JANUARY 16, 2024 | REGULAR MEETING

Town of Stonington  
Planning and Zoning Commission

Town of Stonington | Department of Planning  
Planning and Zoning Commission Meeting  
January 16, 2024  
Summary of Administrative Review Items<sup>1</sup>

C-6

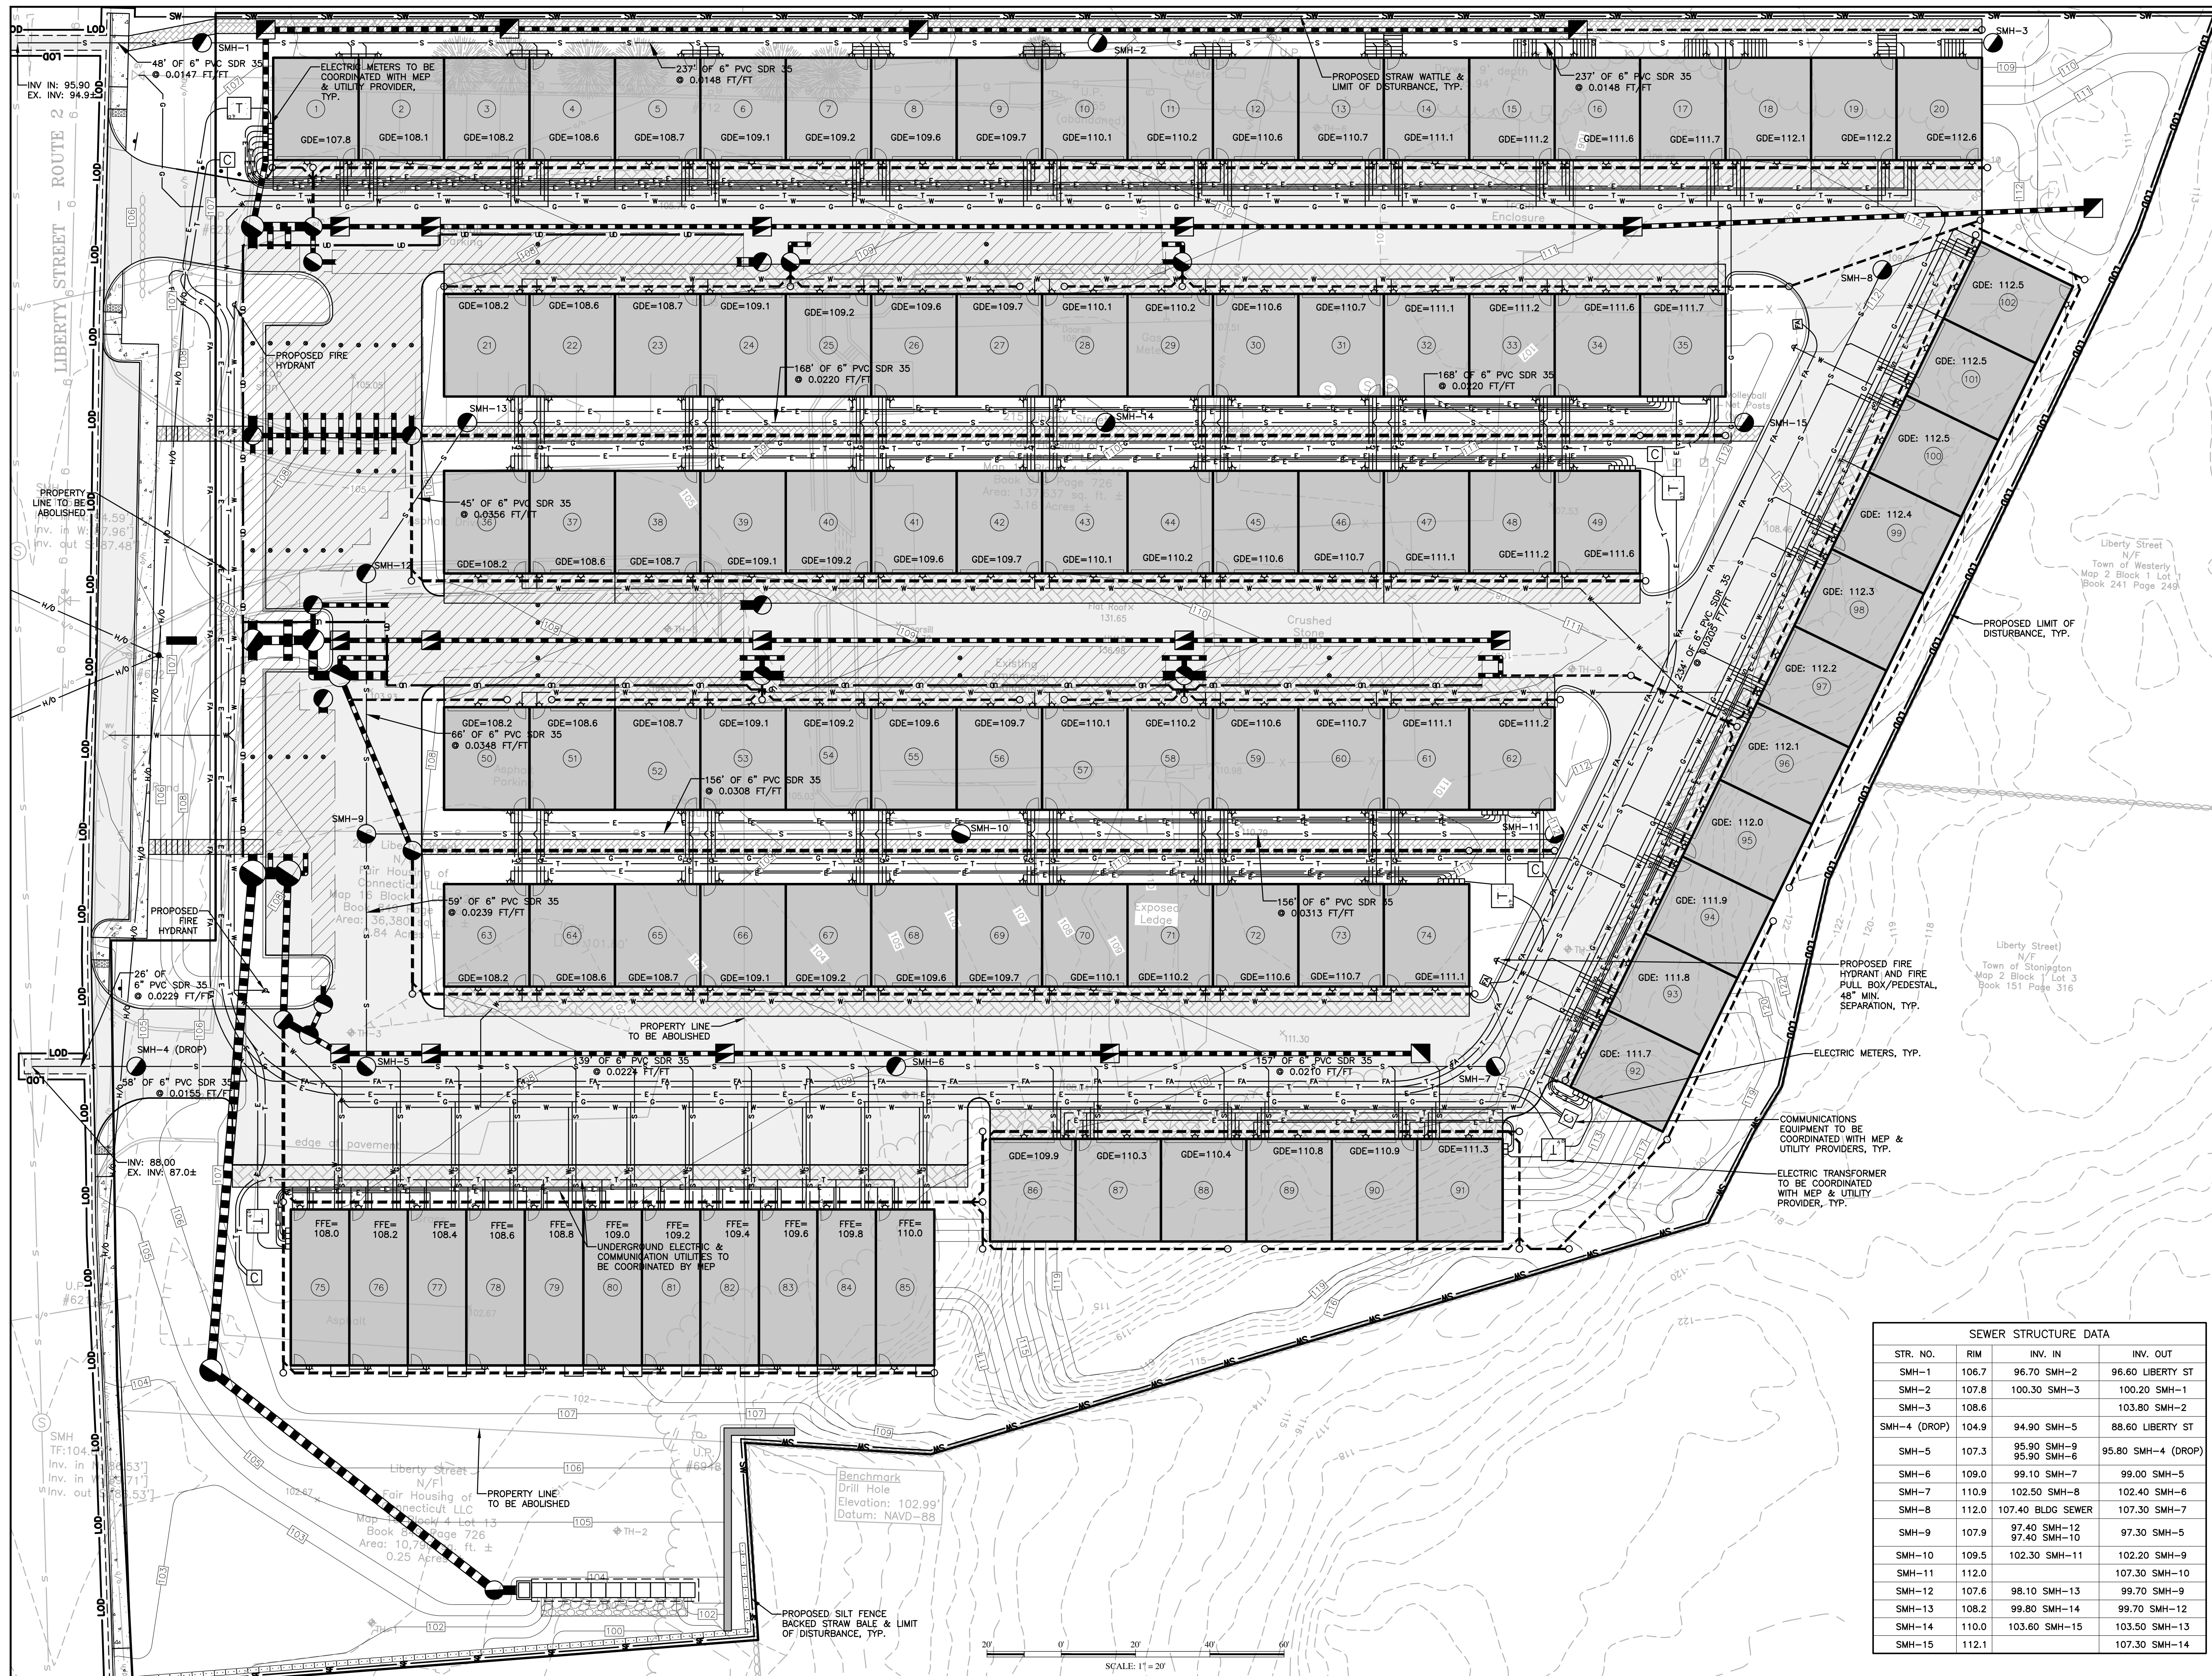
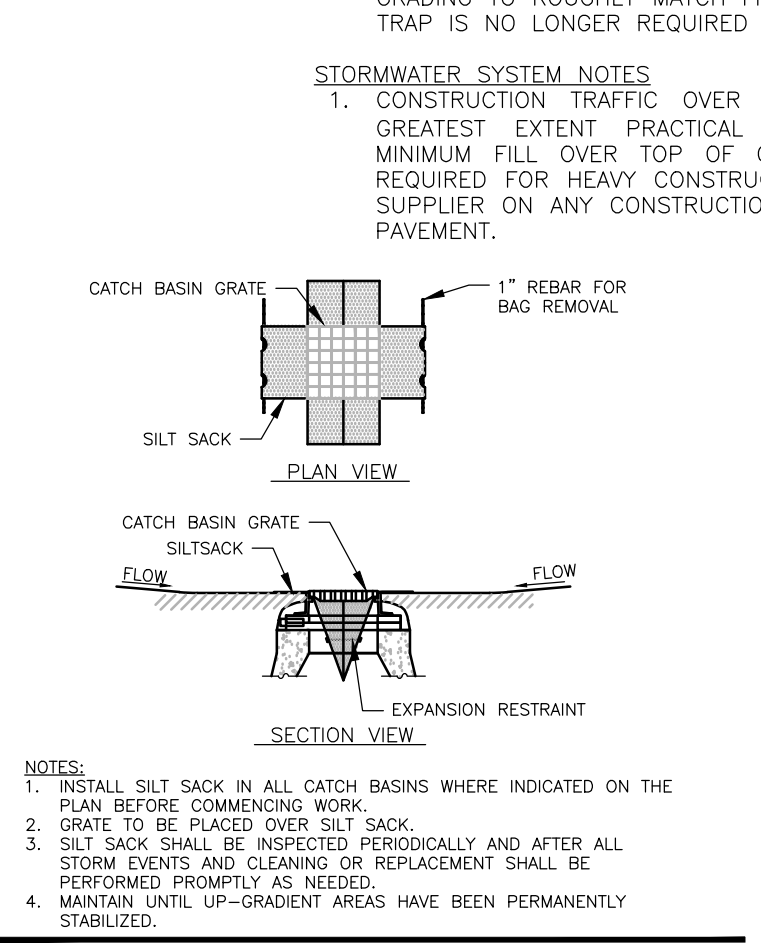
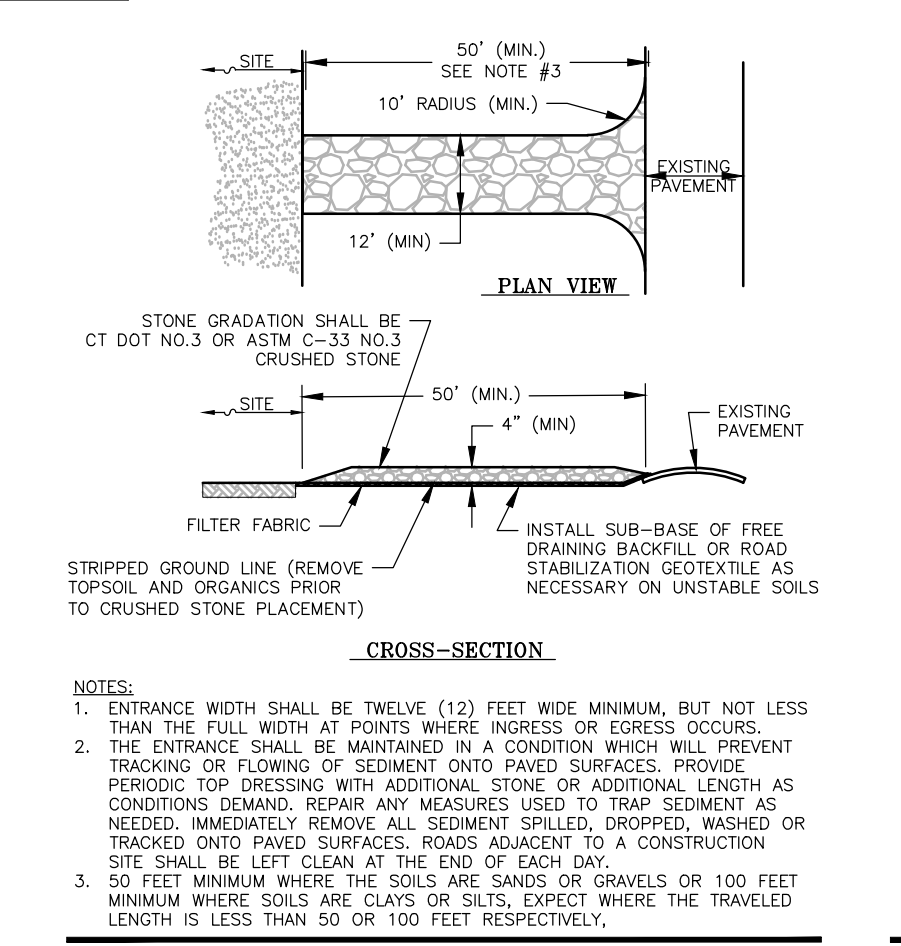
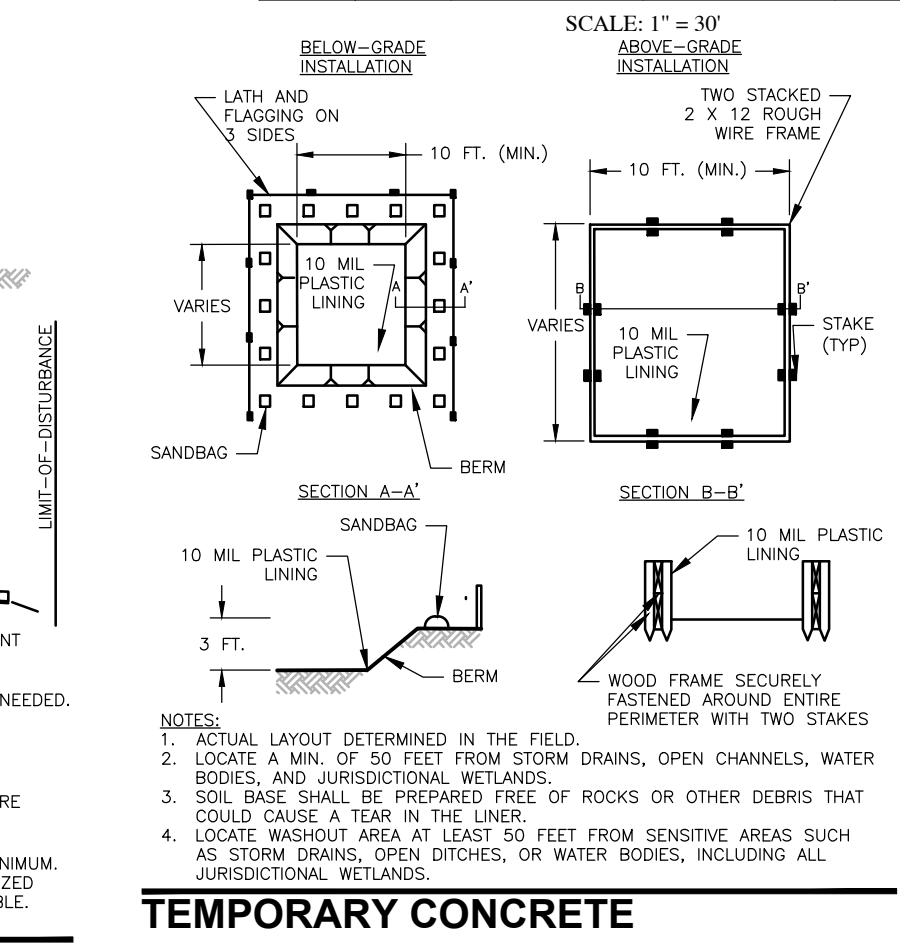
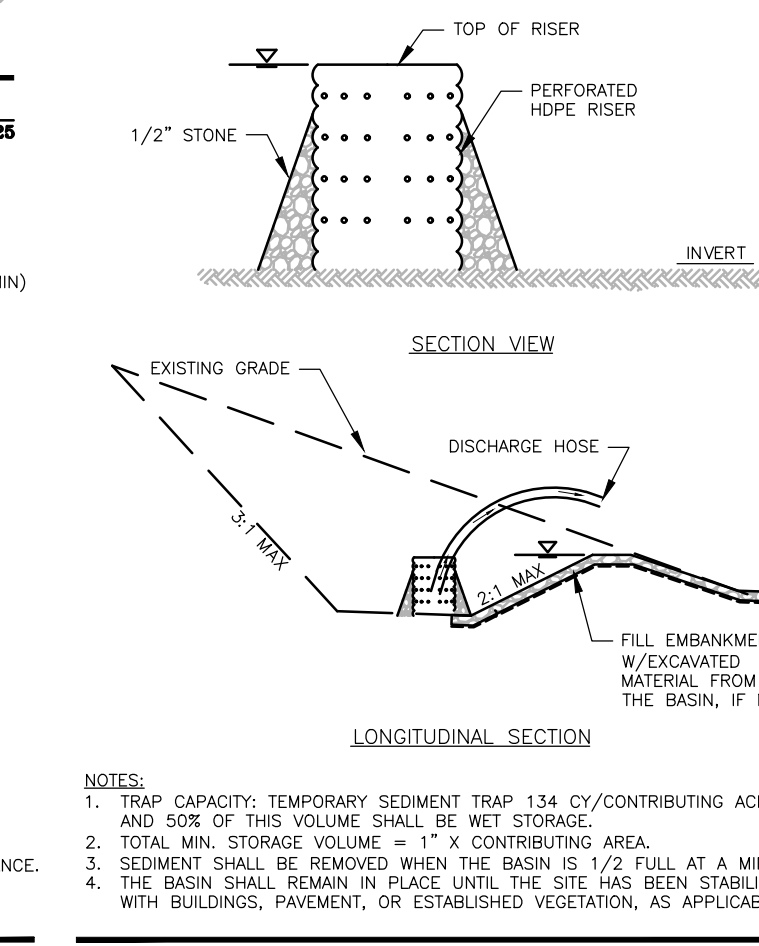
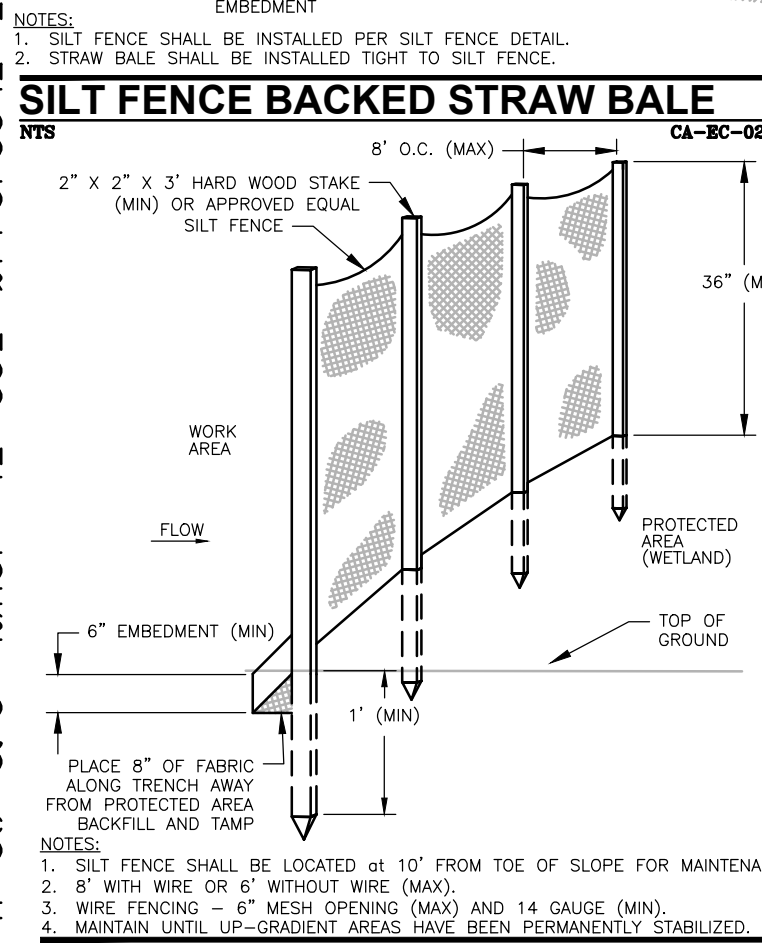
gas lines are not shown on the Utility Plan (Sheet C-3) or on the Architectural Plans (Sheets A.1 – A.9). It is recommended the applicant include proposed natural gas service in the plan set.

Response to Comment: Gas lines are shown on the utility plan, sheet C-6.

Response to Comment: Sheet C-6 of the planset show all the utilities including all sewer structures and their invert information. Sheet C-8 has sewer details. Plan and profiles of the proposed sewer lines can be provided prior to Water Pollution Control Authority approval if required for this project.

Response to Comment: Sewer note #1 has been added to sheet C-6 stating that construction shall conform to the Town's Technical Standards for sanitary sewers. Details for the sewer structures and trenches provided on sheet C-8 of the planset are from the Town Technical Standards.

Response to Comment: Sewer note #2 has been added to sheet C-6 stating that the construction shall be carried out in the presence of an authorized representative of the Town of Stonington Water Pollution Control Authority. The contractor shall coordinate with the WPCA during construction.

Response to Comment: Sewer note #3 has been added to sheet C-6 noting this requirement.

Response to Comment: This has been added as sewer note #4 on sheet C-6.
